**ADDENDUM NO. 1**  
**TO THE BID DOCUMENTS FOR THE**  
**465 SPRINGHILL – PRESCHOOL ELECTRICAL PROJECT**

**FAYETTE COUNTY PUBLIC SCHOOLS**  
**LEXINGTON, KY**

Addendum 1  
Drawing E2.0

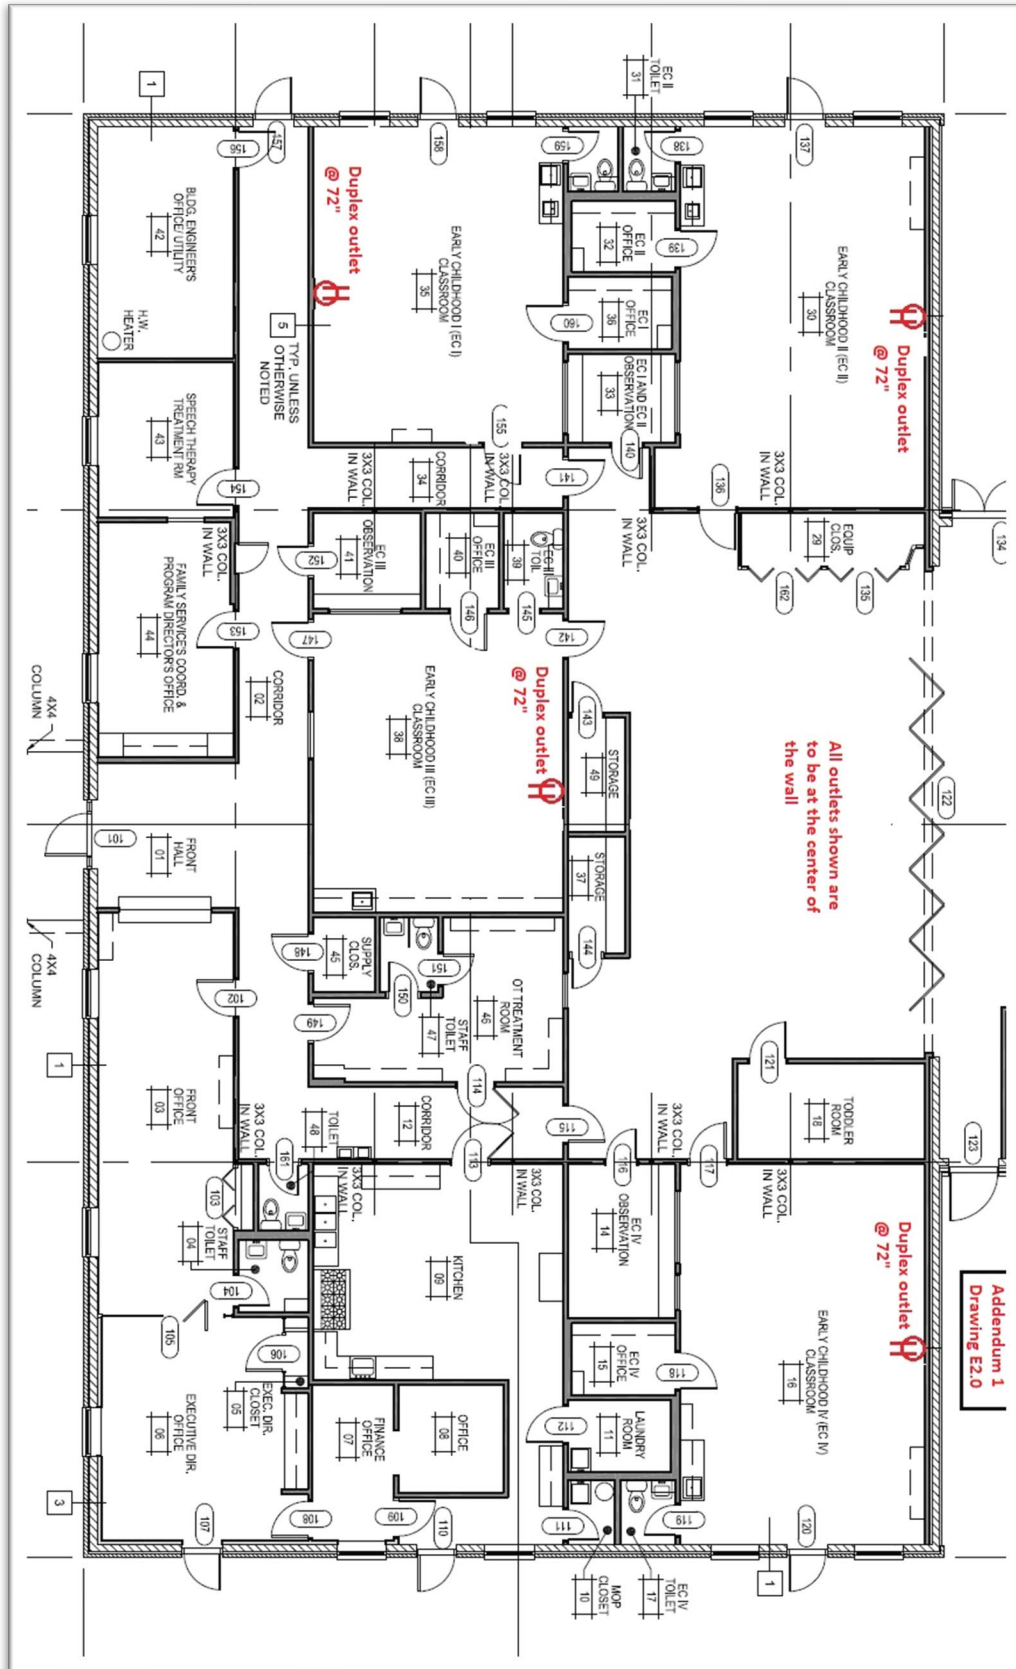
- Add one additional electrical duplex outlet in rooms 16, 30, 35 and 38. Outlet locations in the rooms are provided on the attached drawing E2.0

All outlets shown are to be at the center of the wall
